Technical Bulletin 112

Replacement Program for the Model 8000/8100 Btu/CV Transmitter Stream Selector Module

Version 1.0, Revision AA (5 December 2003)

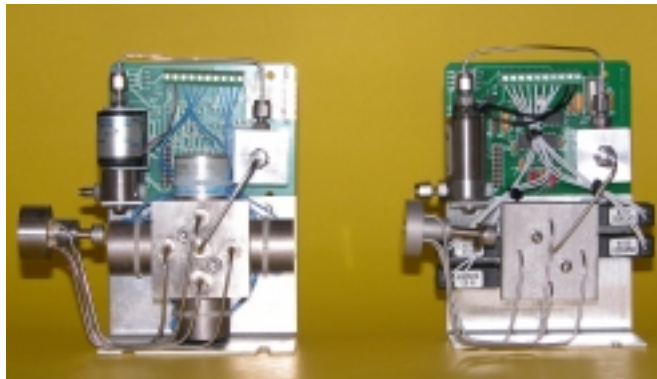
The Model 8000/8100 Btu/CV Transmitter has been improved by re-designing the Stream Selector Module (SSM) (P/N 2015615). The main difference is that the Neptune Research solenoids and the Teflon manifold have been replaced with Burkert valves and an aluminum manifold. These new SSM's (P/N 2015615-002) are currently being shipped in new Model 8000/8100 Btu/CV Transmitter except those designated for areas or countries that require Type or Metrology approved units. These are at present the Btu Transmitter needing the P/N 2013947-002 in their model number.

The two units are shown together for comparison in the figure below. The SSM with Neptune Research valves, P/N 2015615-001 is on the left. The SSM with the Burkert valves, P/N 2015615-002 is on the right.

This improved valve (2015615-002) uses the same electronics and the same bracket that the older SSM (2015615-001) used, and can be replaced directly in the Model 8000. It has an aluminum manifold block and Burkert solenoid valves. It should work more reliably and is therefore being replaced in units that are experiencing Stream Selector problems while under warranty. Because this valve may be more desirable than the older, Neptune Research valve unit, the following change out program is being made available.
